BRIEFING RESPONSE MEMO

SUBJECT: Issaquah Studio Lofts
Project No. PRJ17-00012
Site Development Permit SDP17-00003

City Staff and the applicant are providing the following information in response to the Development Commission's and the public's questions and comments offered at the April 4, 2018, Public Hearing (Part 1), as well as comments received by Staff following the Public Hearing.

Figure 2. Design Manual Draft Map (pg. 61)

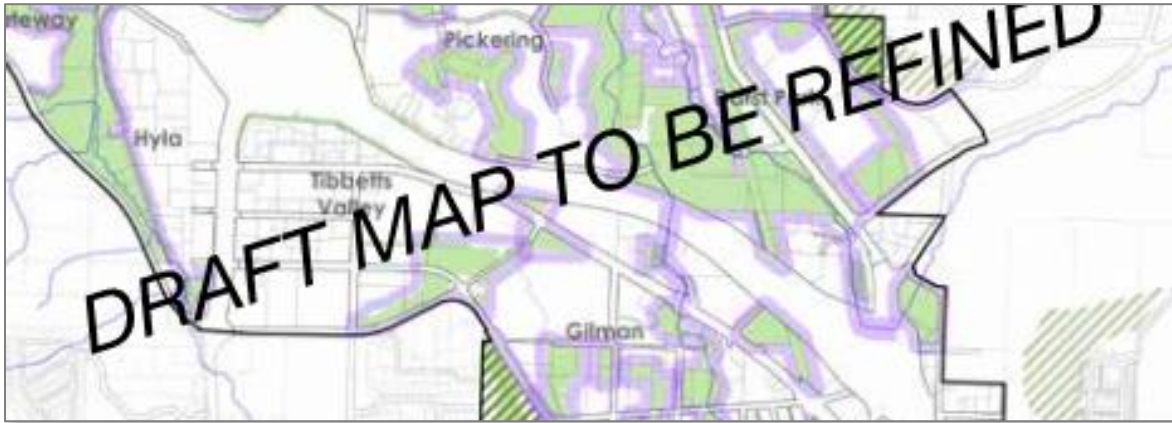
2.1.C Natural Context: The Draft Map provided in the July 20, 2017, Draft Design Manual, which is included as Figure 2, indicates that the map is "to be refined". Following the adoption of DA17-00001,

the applicant and Staff began working on the design of the site and the building. Staff considered the “to be refined” statement to be ambiguous and acknowledged that the Natural Context areas were subject to change. To this end, Staff determined that the Natural Context requirements would not be applied to the project.

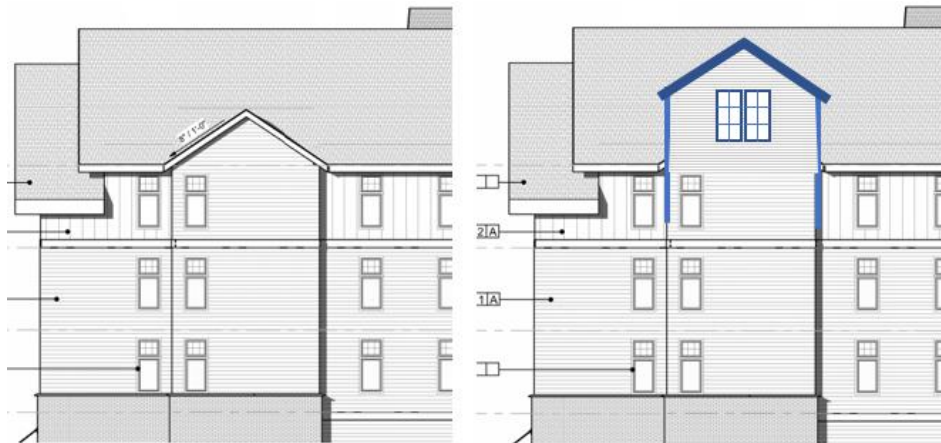
- A. Provide more information about the stair towers and elevator towers as compared with the Arts & Crafts Style in the Design Manual. Contextually, the gables, dormers, and roof do not seem to really fit with the examples of that style.
- B. The Development Commissioners generally disagree with some of staff’s findings that the proposed design complies with some of the items on page 164 of the agenda packet, such as compliance with the requirement for a steep-pitched roof. Elements of the Arts & Crafts Style are there, but because it is such a broad building, the concept falls apart somewhat.

2.2 A – G: In consideration of the comments and concerns received during the Public Hearing, the applicant submitted revised plans on April 13, 2018. Staff subsequently conducted analysis for compliance against the Draft Design Manual. The analysis, along with additional land use comments, was provided to the applicant on April 18, 2018. Exhibit D, a revised set of project drawings dated April 19, 2018, considers the comments and analysis provided to the applicant by Staff. A new analysis against the April 19th project drawings provided by the applicant was conducted by Staff and has been included as Exhibit C. **New Condition Nos. 26-31** have been added as a result of this latest Staff analysis, and are detailed in the Conclusion portion of this Section.

- A. The stair tower on the east façade and the elevator tower on the west façade have been redesigned to align more with the Arts & Crafts Style. In the Central Issaquah Architecture & Urban Design Manual on pg.13, prominent stone chimneys are listed as a part of the Arts & Crafts style. The elevator tower on the west facade has been adjusted to provide a chimney element with a steep gabled roof to add roof complexity. The stair tower at the east façade has been revised to provide an additional gabled roof. The shallow roof pitch that previously was shown on the towers have therefore been removed. Refer to the elevation sheets A3.00 and A3.01.

- B. Per the Central Issaquah Architecture & Urban Design Manual on pg.18, steep pitches are appropriate while low pitches are not. The low pitched roofs previously shown at the elevator and stair tower has been removed and replaced with an 8:12 gable roof. The prominent roof slopes originally at 10.5:12 and 6:12 have been adjusted to 8:12. Refer to the elevation sheets A3.00 and A3.01.

- C. One simulated wood style has been eliminated. The three materials shown are board and batten siding, lap siding and brick. The towers have been redesigned per responses a and b above. Windows have also been added to the east stair tower as requested. In the Central Issaquah Architecture & Urban Design Manual on pg.21, windows as single, pairs or groups of three are listed as appropriate. Windows have been designed to comply with these requirements. Refer to the elevation sheets A3.00 and A3.01.

Above: East wing, east elevation: Existing, Revised

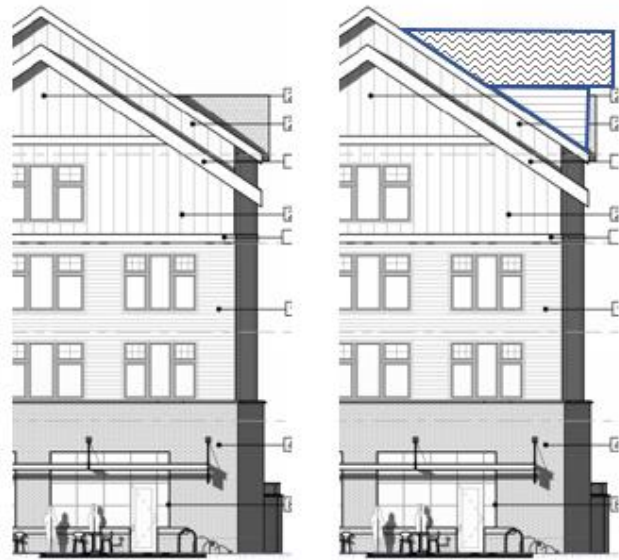
Item #1: Massing roof forms. Arts & Crafts style has “more complex roof forms” including “steep pitched roof forms”, “gable ends and dormers”, and “intersecting ridges (or cross gable roof)”. The applicant has made all roofs steep per the definition in the adopted Design Manual and has reduced the number of roof pitches to one (8:12), also consistent with the architectural style. Additionally, the applicant has changed the roof on the stair towers from shed roofs to gable roofs, consistent with the Arts & Crafts style. However, the question is: is the roof form complex enough to meet the intent of Arts & Crafts? No definition of complex is given other than the Massing phrases excerpted above and the photos in the Design Manual. Below is a comparison of the how the roof forms have evolved from the original proposal sent to the commission and the revised one prepared for the May 2, 2018, Hearing. The revised proposal is similar to the top image shown on the Massing page; see Exhibit C.

1. Making the stair towers taller with a more prominent intersecting ridge and/or cross gable. Staff have roughly simulated this below, recognizing that a more careful design of this would be necessary. This would be above the stair tower which might offer a larger attic workspace:

NEW CONDITION NO. 26: Massing – Roof forms shall be complex through the use of dormers and/or increasing the scale of the stairwell roofs to create more visible intersecting ridges.

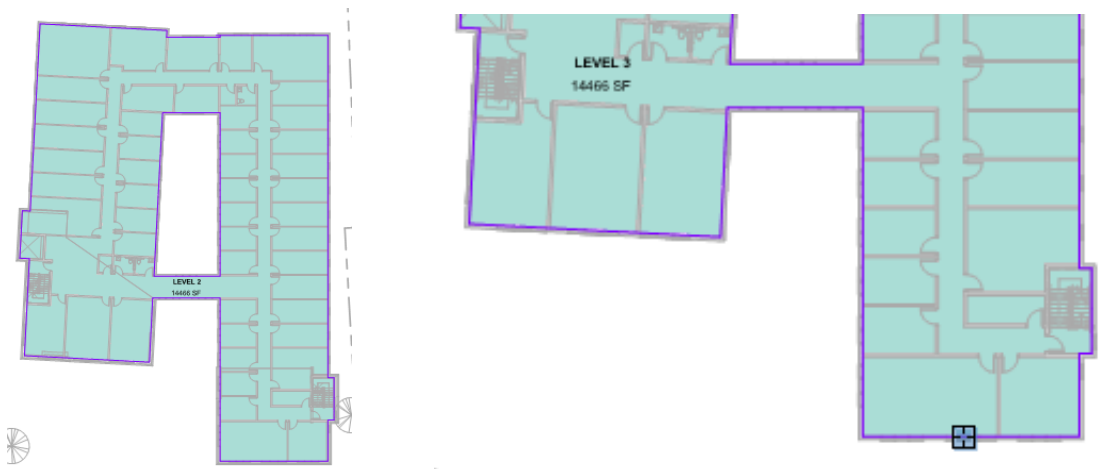
Item #2: Asymmetrical. Arts & Crafts style has an “asymmetrical composition (in both elevation and volume)”. No other definition of asymmetrical is provided other than the photos, which vary in the degree of asymmetry. The volume is already asymmetrical given that the two wings are not parallel and are different lengths; see below left.

However, the facades are identical which increases the perception of symmetricalness. This is somewhat surprising since 1) the west wing is about six feet wider than the east wing and the floor plans behind the south façade are different e.g. three workspaces vs two workspaces; see above, right. Even if the facades each remain symmetrical, changes to reflect some of the distinctly different workspace configurations and different windows or even slight material changes and color could improve the asymmetry. For example:

NEW CONDITION NO. 27: Massing – The composition is not asymmetrical. The applicant shall revise the design to achieve the required asymmetrical composition through the use of materials, window groupings, and/or colors.

Figure 3. Pedestrian Walkway Width

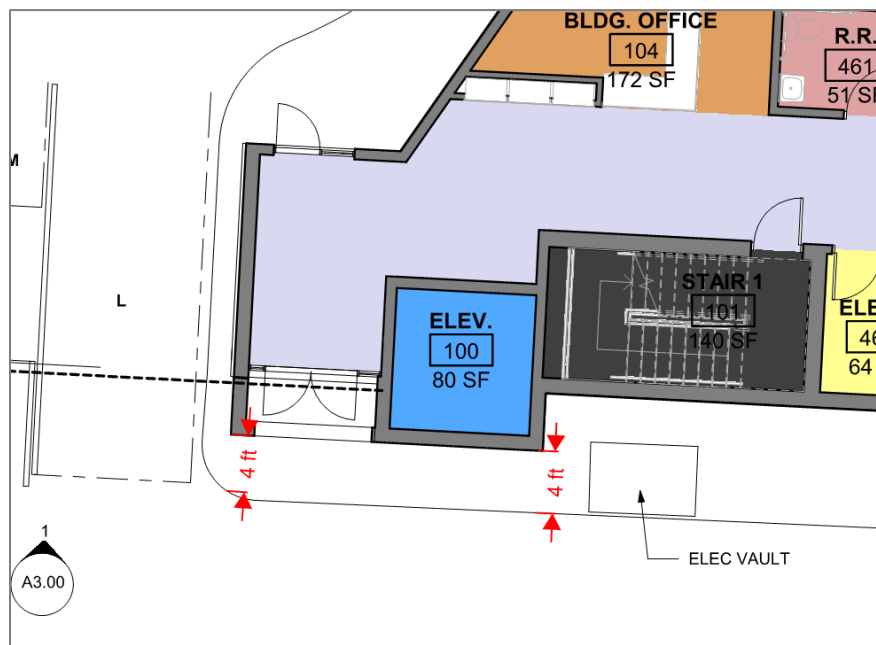
- A. The elevator shaft sticks out about two-thirds of the way into the walkway, creating a safety issue when cars enter the site and pedestrians are walking there.
- B. Garage lights should not be visible from Gilman Blvd. Screening should be provided coming down from top of garage.

4.A Elevator Shaft: The elevator shaft on the west portion of the building has been modified to increase the pedestrian walkway from three feet to four feet; however, compliance with the five feet required for pedestrian walkways per the CIDDS has not been achieved (CIDDS 15.2.D, 15.3.D, 15.4.C). Therefore, **New Condition No. 32** has been added.

- A. The elevator shaft has been shifted into the building so that it now sticks out one-half of the walkway as opposed to two-thirds. The walkway in front the shaft is now shown as 4'-0" wide. Refer to the site plan on A1.00.

NEW CONDITION NO. 32: Pedestrian Walkway – The applicant shall revise the plans to accommodate a five-foot clear walkway, between the curb and the west stair tower.

Figure 7. Trail Plaza Plan View

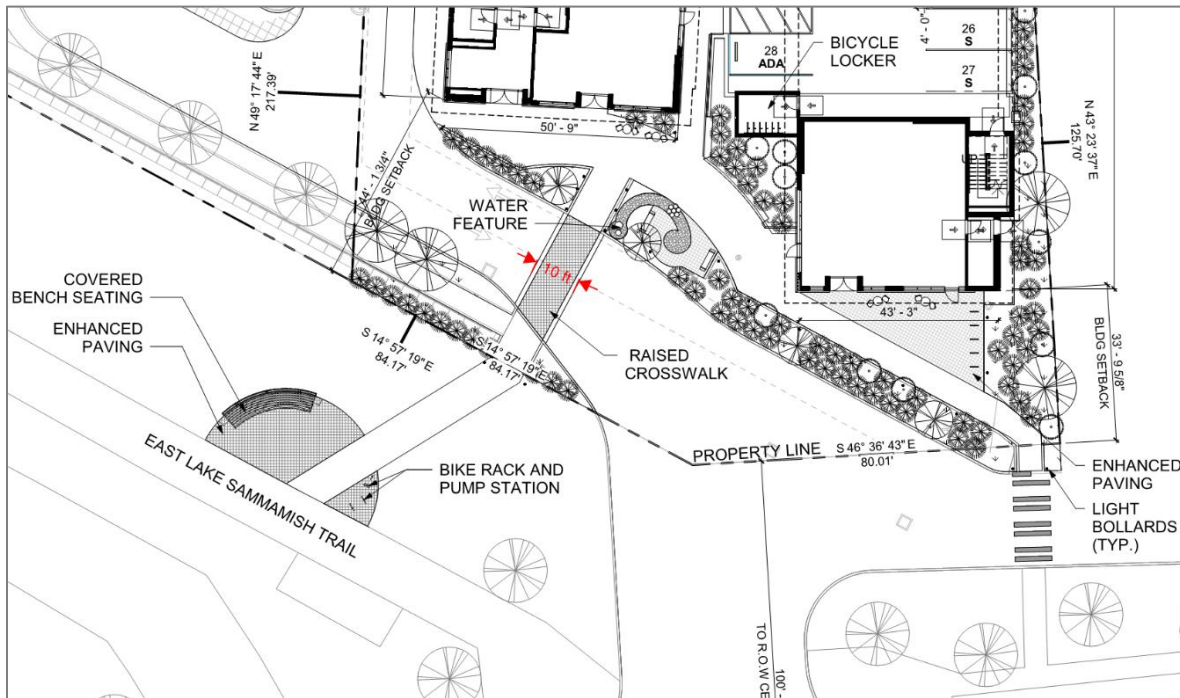
4.F Through Block Passage: As discussed in the Staff Report, the block length exceeds 300 feet; however, Interstate 90 is located directly behind (north) this block and there are no opportunities for additional through block passages. Nonetheless, a trail connection would be provided to connect the East Lake Sammamish Trail to the plazas located at the entrance of the Issaquah Lofts site as shown in Figure 7.

- A. The design is not the verdant, multi-dimensional frontage envisioned for the entrance to the East Lake Sammamish Trail.
- B. The trail connection and plaza are a critical intersection that should be a signature feature for the City.
- C. The trail plaza should be “active and memorable” and a place of arrival and celebration.
- D. More people should be involved in the design of plaza (King County, Parks Dept., Public Works Dept., Issaquah Alps Club, Mountains to Sound Greenway, etc.).
- E. Raised crosswalk:
 - 10 feet wide
 - Colored concrete

5.1.A - E: On Tuesday, April 17, 2018, Staff hosted a stakeholder meeting which included a representative from the Mountains to Sound Greenway Trust, a representative from the Issaquah Alps Trails Club, two City Parks and Recreation Department Staff members, a City Public Works Engineering Staff member, two members of the City Development Services Department, and members of the applicant's team. King County Parks and the Cascade Bicycle Club were both invited but were unable to participate, though King County Parks provided written comments pertaining to standard details. The result of that collaboration meeting has been incorporated into the revised project drawings.

- E. A perspective view from the Pogacha site of the proposed building has been provided on G0.02.
- F. Given that the I-90 is behind the block, there are no opportunities for additional through block passages. The pedestrian experience of the block length, however, is reduced through the connection provided from the East Lake Sammamish Trail to the building plaza.

- B. It is understood that the trail connection and plaza is a critical intersection. Comments from the stakeholder meeting on 4/17/18 have been taken into consideration and applied in the new design. The plaza has been shifted further away from the intersection to provide a safety buffer from automobiles as well as to caution bikers that they are entering a developed area. Covered bench seating and bike rack with pump station provides an amenity for bikers/trail –users as they continue their journey. Refer to sheet A1.00.
